RE: SES Solar One Project
Applicant's Responses to the CEC Memo Regarding Transmission Line Upgrades

SES Solar One
Response to CEC Memorandum
Docketed 12/8/2009
08-AFC-13

TECHNICAL AREA: TRANSMISSION LINE UPGRADES

PLATE:
4

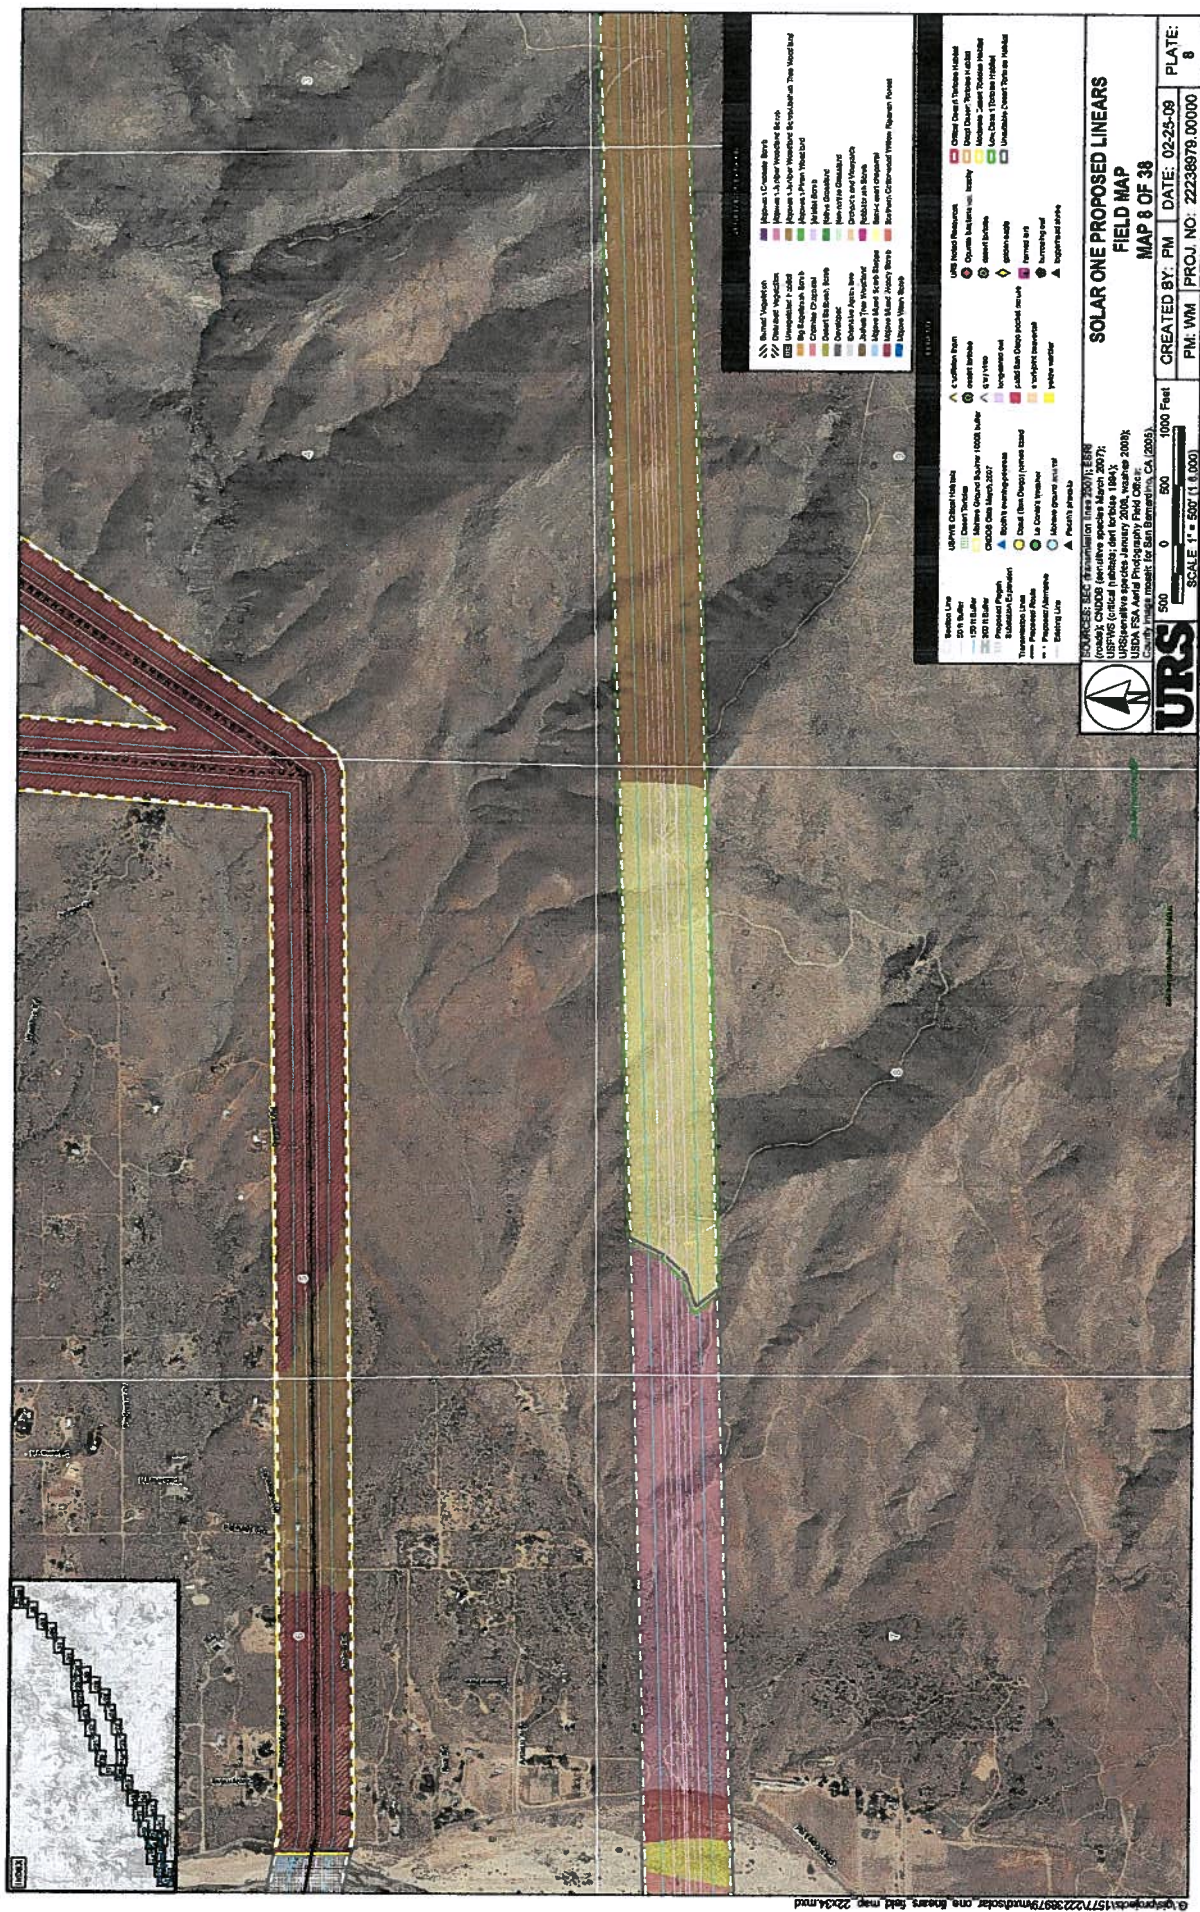
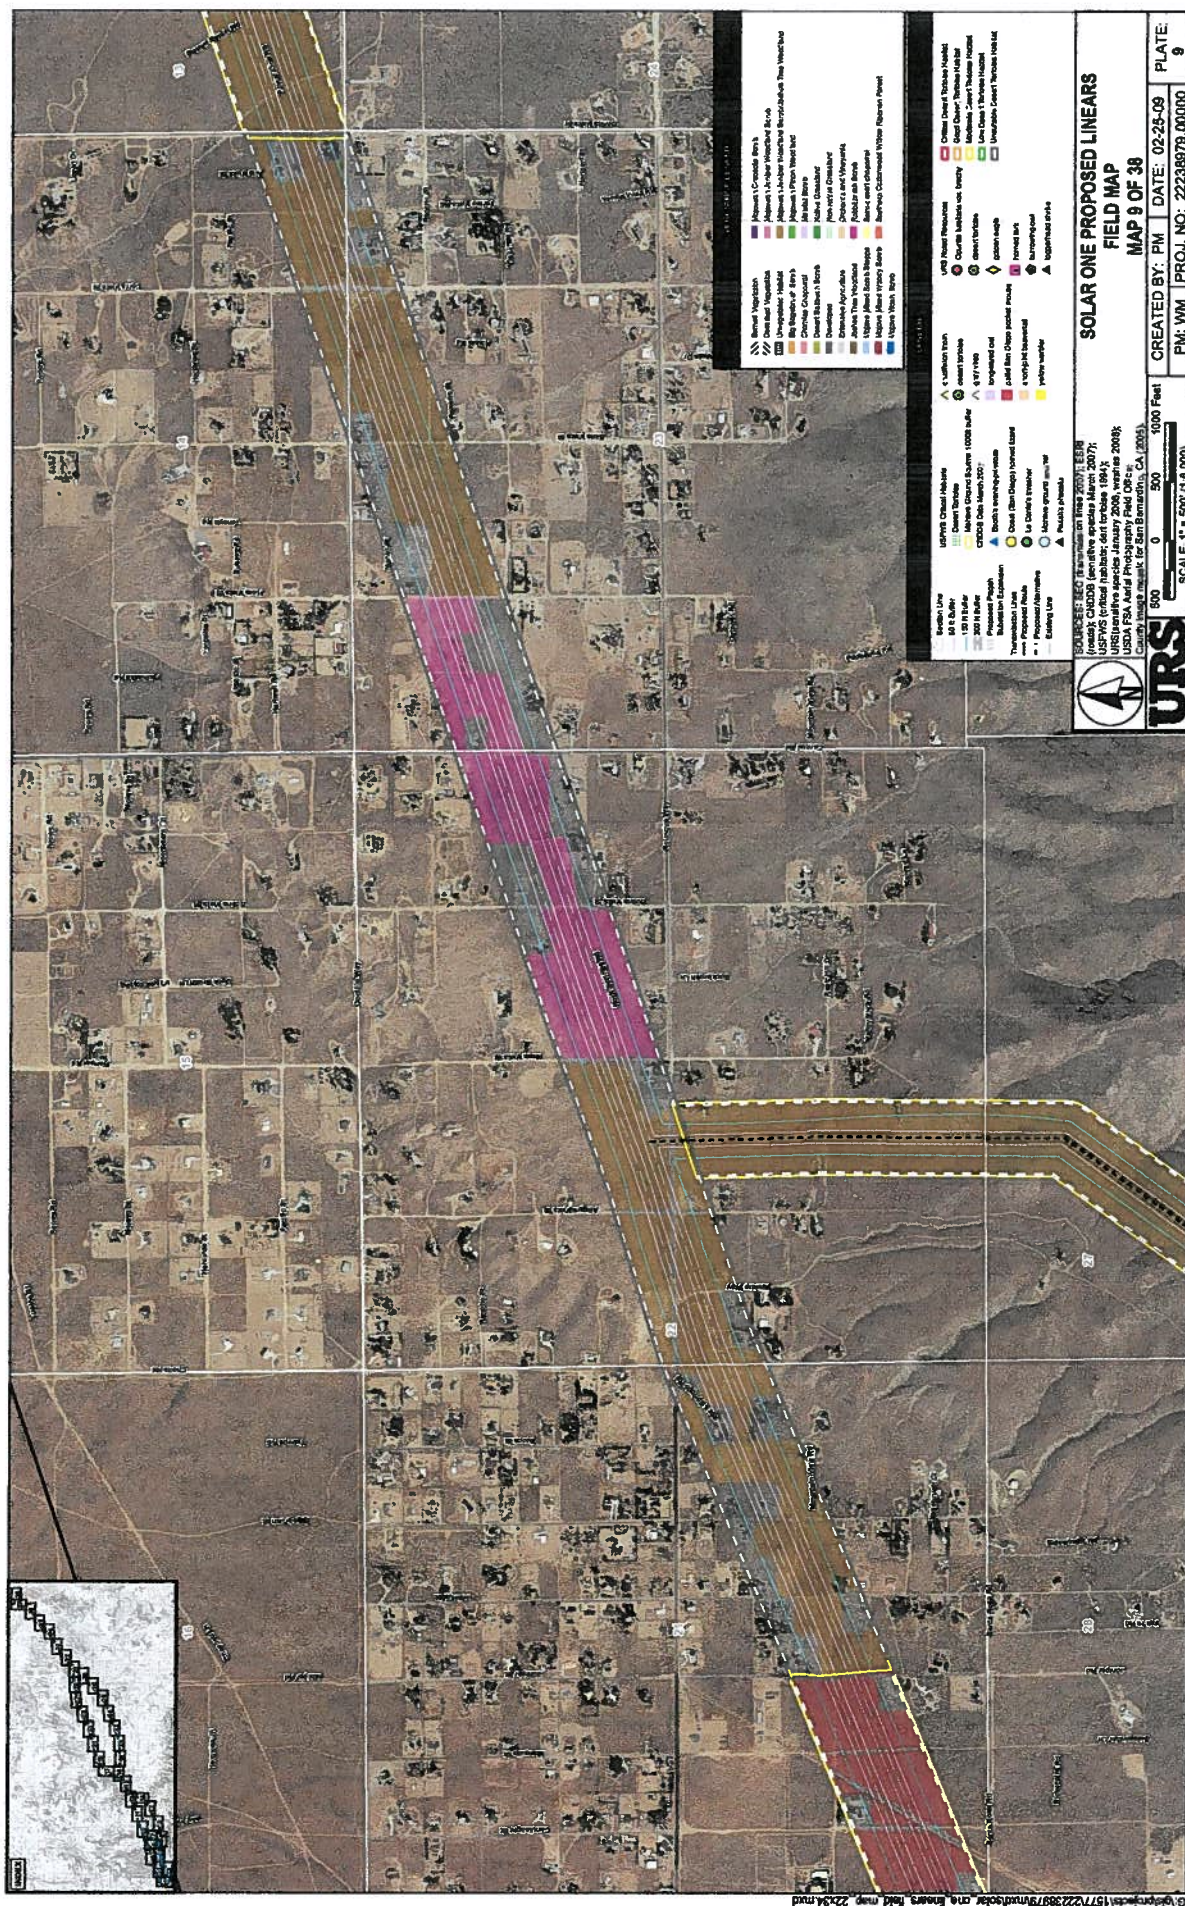
Item 1: For the areas affected by the transmission line upgrades, provide information related to special-status species surveys for both plants and animals done when the organisms are identifiable (multiple trips out, especially for plants)

Response: Maps of vegetation types and special-status species locations along the transmission line are provided as attachment TRANS-1 provided behind this response. The abundance and location of each special-status species that was detected during surveys are provided below as Table 1. The survey dates and personnel conducting each survey are provided in Table 2.
